Date: July 7, 2020

ADDENDUM NO. Two (2)
PROJECT NO: 116769R
TITLE OF PROJECT: Dam Reconstruction
FACILITY LOCATION: Bastrop State Park, Bastrop County Texas

116769R Bastrop State Park Dam Replacement

101 IRONWOOD ROAD MIDDLESBORO, KY 40965 PH: (606) 248-5560 FAX: (606) 248-6308 JRHOE.COM	TITLE: LPK-6060 60"x60" PEAKED ROOF TRASH RACK	
	SIZE B	DWG. NO. 173500
		REV. 0 SHEET 1 / 1

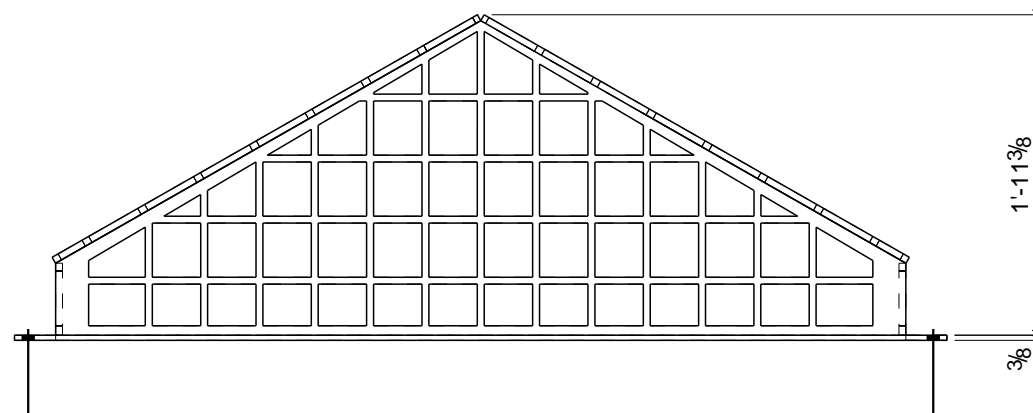
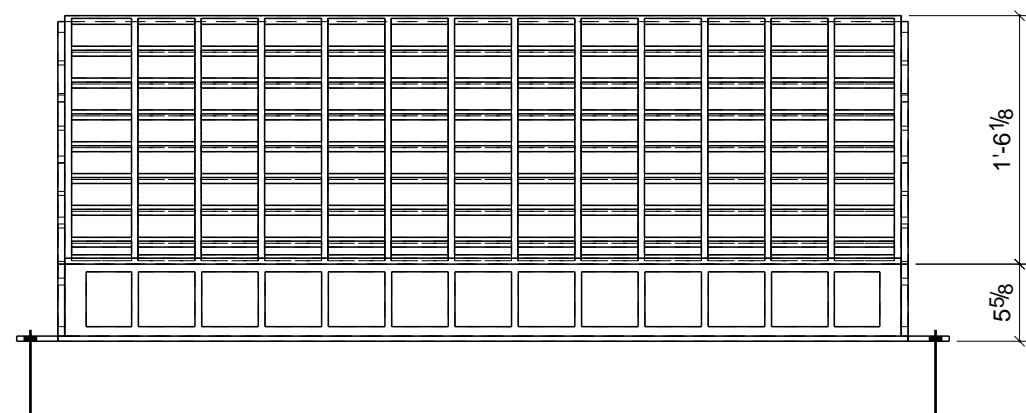
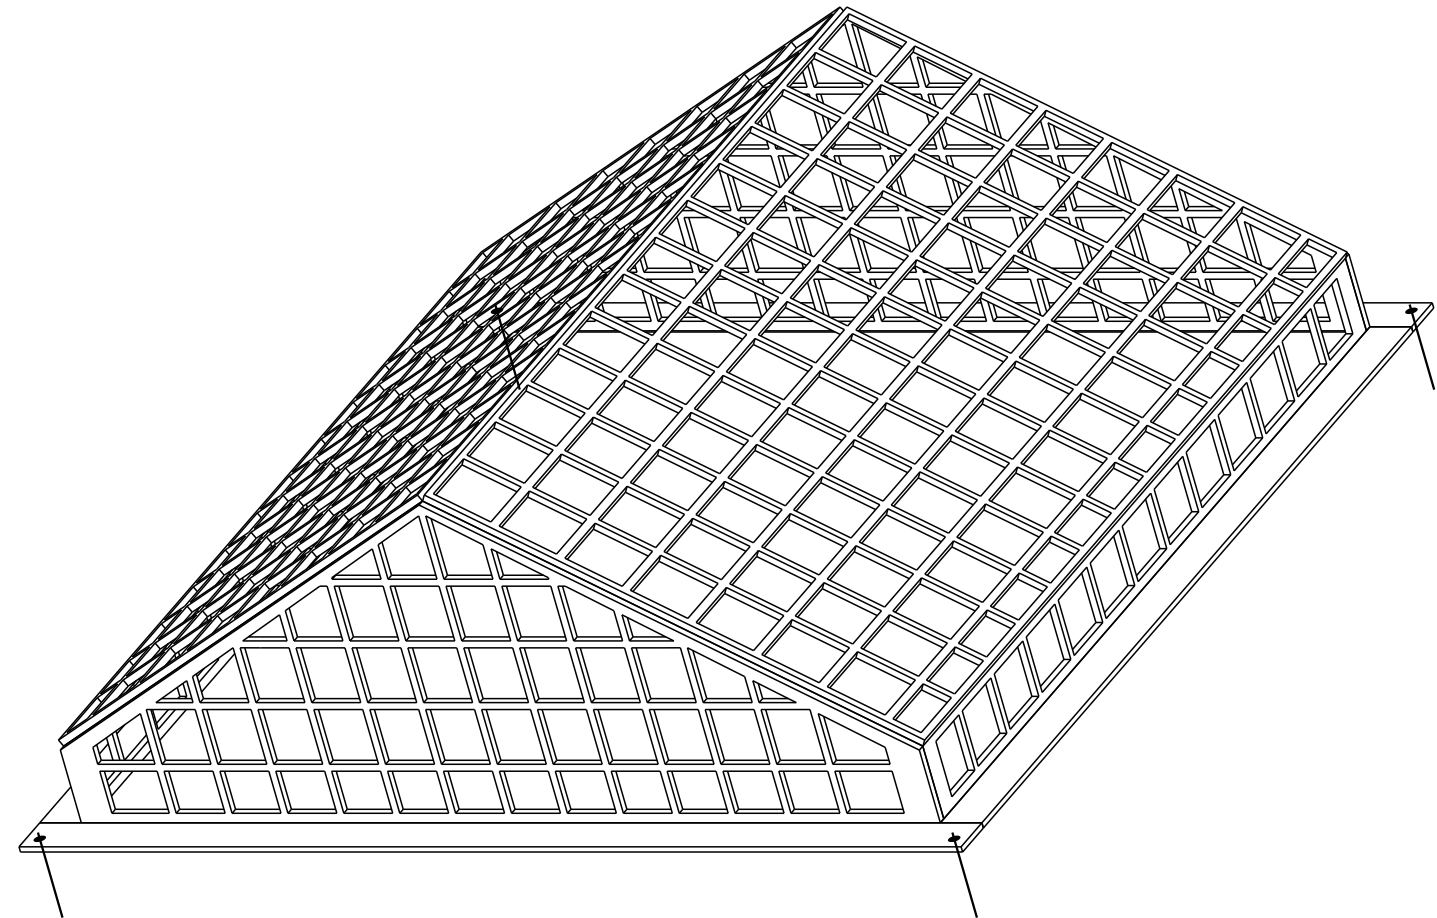
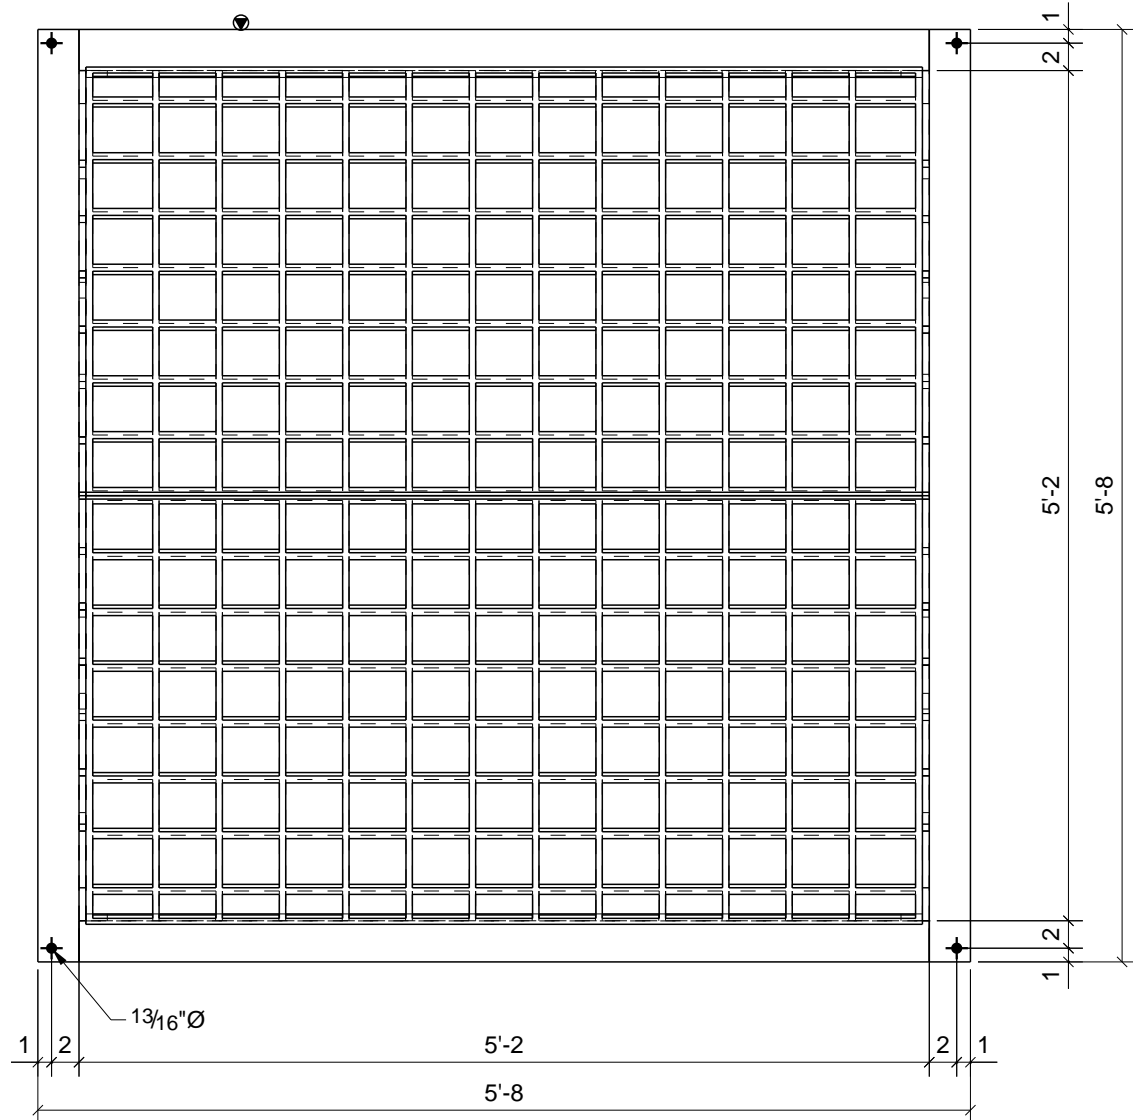
Q23. Drawing 70 of 150, Trash Rack Detail states to "Reference Specifications Appendix B," please provide specification

A23. Reference Manufacture's information included with this response.
